Bath Eastern Park and Ride Site Options

Bathampton Parkway

Review of Dorian Baker report dated 6th
February 2012

Revision 01

BATHAMPTON JUNCTION AREA - ORIGINAL LAYOUT WITH AMENDMENTS TO D. BAKER REPORT

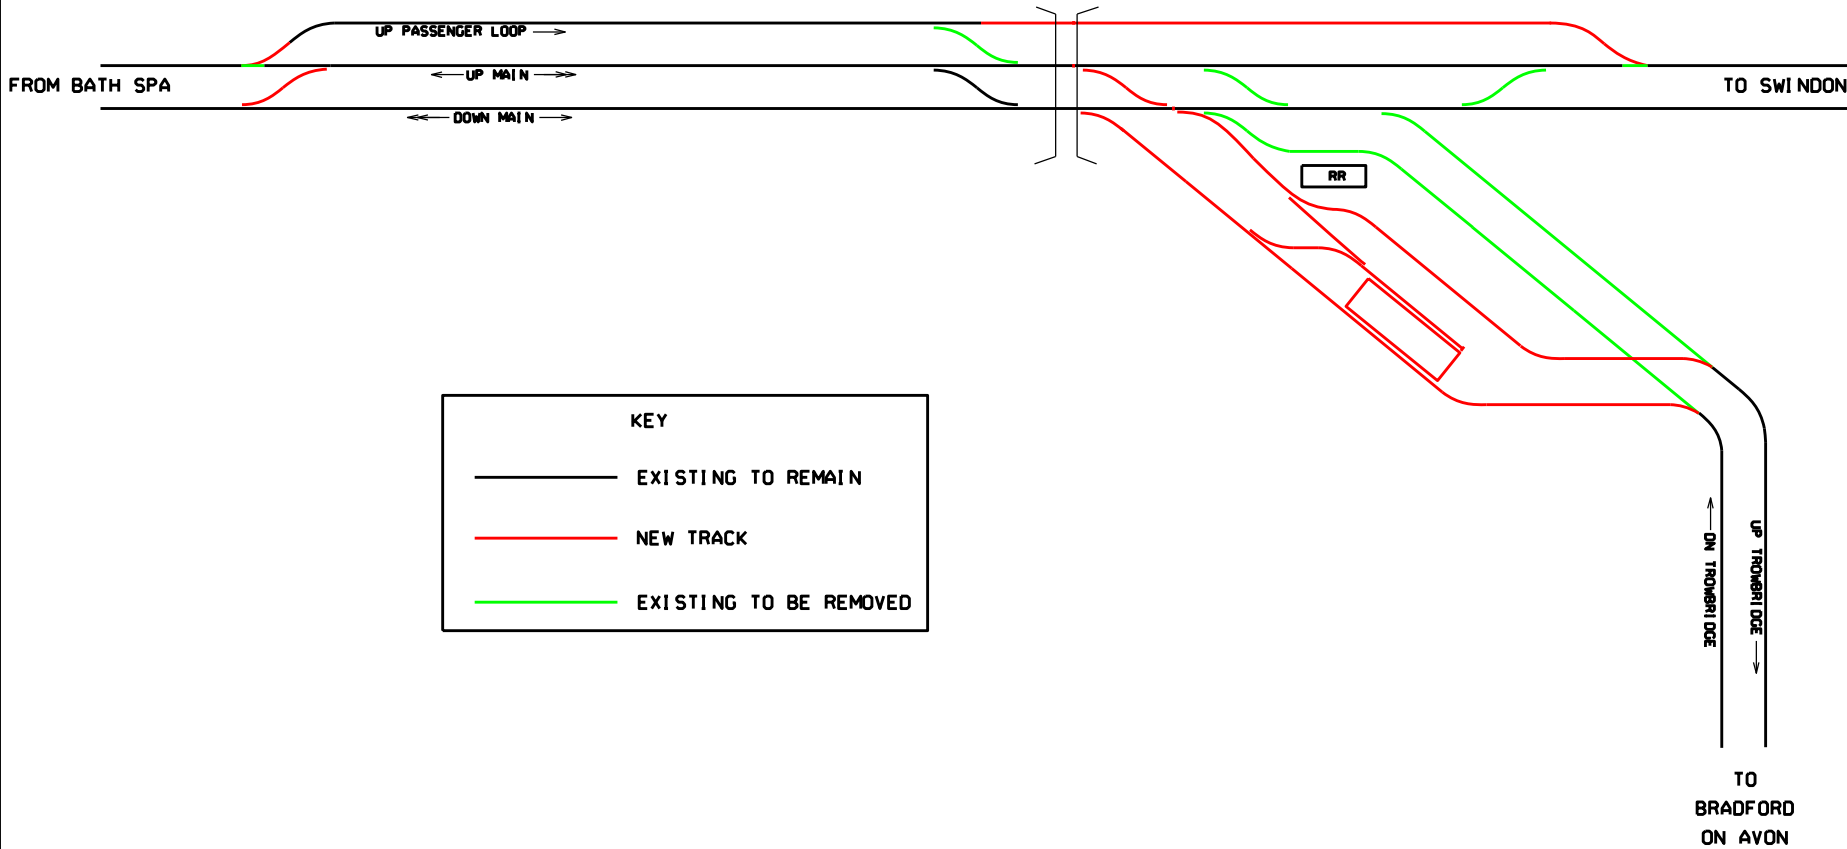
Appendix A Line Diagram of Bathampton Junction Area

(Showing amendments as proposed in D. Baker report)

The proposed Bathampton Park & Ride railway station and car park.

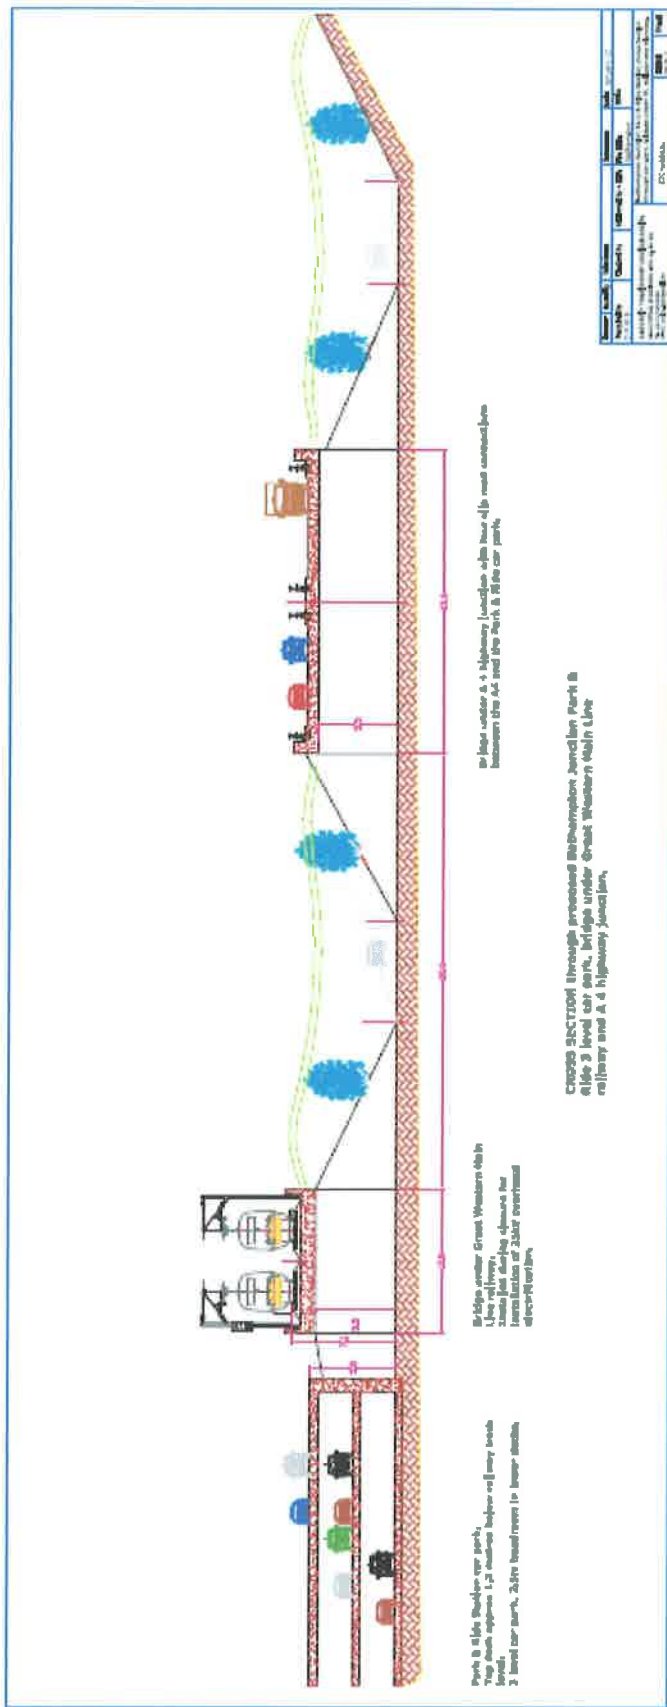
3.1	<p>The new infrastructure is in the angle of the railway junction, with the Trowbridge line tracks moved westward to enable the existing area of brown land of the original Bathampton Station site to be utilised as a single plot and to ease the radii of curvature of railway tracks through the curve and at the junction fittings.</p>	<p>The proposed curves are very similar to the existing. There is no significant improvement.</p>

Diagrams of the existing and feasible alternative track layouts at Bathampton Junction

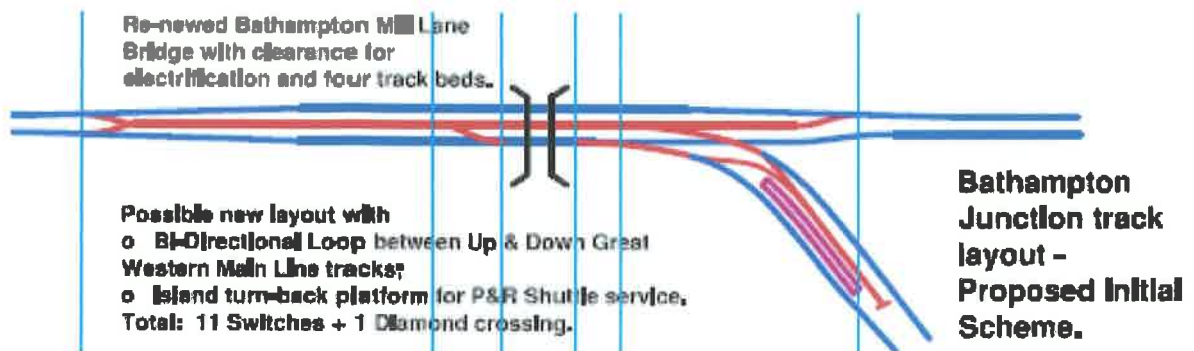
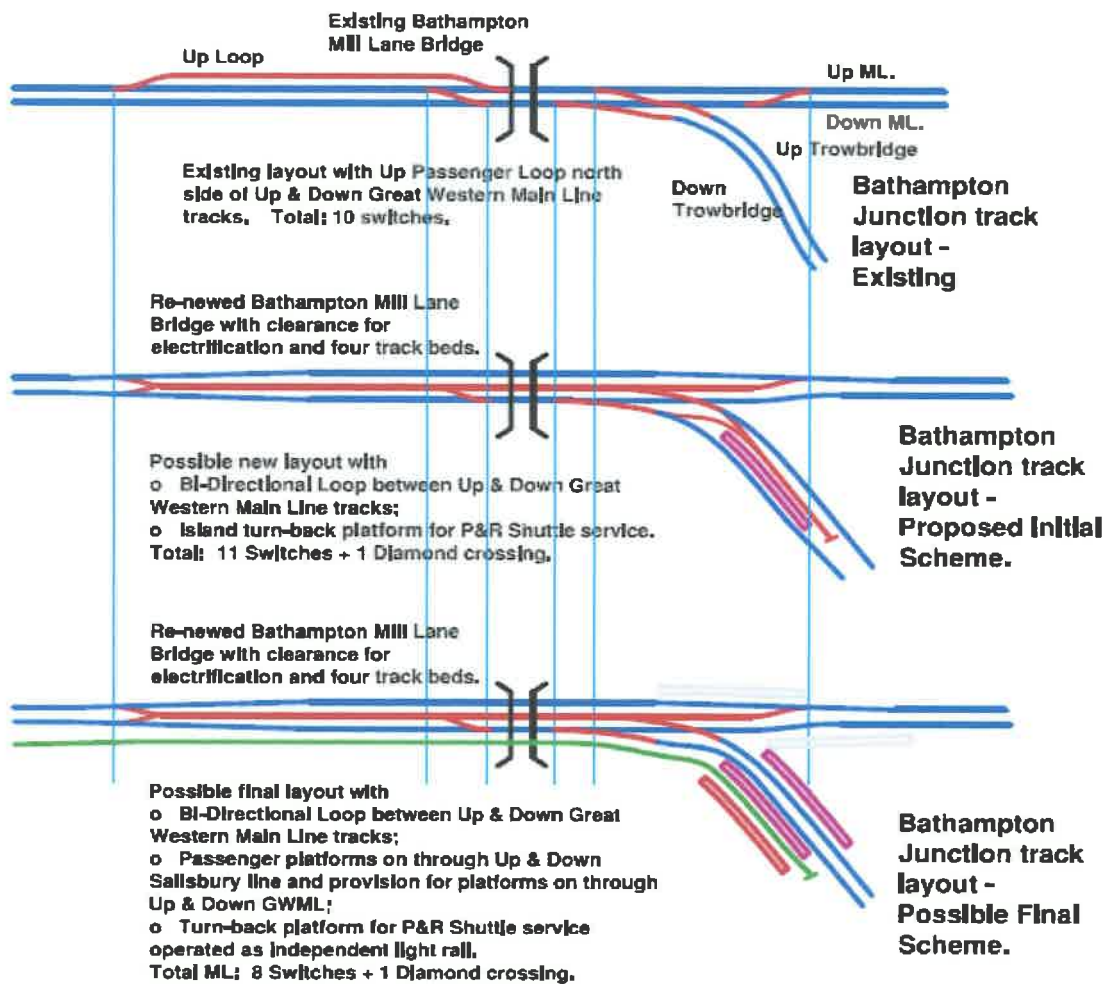
8.3	<ul style="list-style-type: none"> • Weaknesses of the existing layout are that: • The route through three switches between the Up Main and the Up Trowbridge including two reverses of curvature on un-canted track with the result that speed through this junction is limited to 40mph. • The existing layout of the Down connection from the Trowbridge line onto the Down Main also includes two reverses of curvature which, although less severe than the Up direction curves, limit speed to 50mph through the junction in the Down direction. • All Up Trowbridge trains leave the Up Main at a ‘facing cross-over’ at which they cross to the Down Main. This means that for each Up Trowbridge train, the working time-table must 	<ul style="list-style-type: none"> • There is nothing unusual in this and it is not correct to imply that it is just the reverses that limit the speed. As stated above, other technical and operational factors will also determine the appropriate junction speed. • As above • This is normal at flat junctions. The new layout offers no advantage and possibly increases the difficulty in getting Trowbridge trains off the

<p>provide co-incident train-paths in the Up Main and in the Down Main at Bathampton Junction;</p> <ul style="list-style-type: none"> • If a Trowbridge train is held in the Up Loop it must rejoin and cross the Up Main again before it can cross to the Down Main and take the connection to the Up Trowbridge line, hence it still requires coincident paths in the Up Main and in the Down Main. 	<p>Up GWML. Only grade separation would avoid this, and the report does not propose or seek to justify such a solution. We do not see a specific need for grade separation.</p> <ul style="list-style-type: none"> • This is only an issue if there is no choice but to path such a train via the Up Loop. However, this is unlikely as to slow into and accelerate from the loop would take more capacity than pathing it straight across the junction.
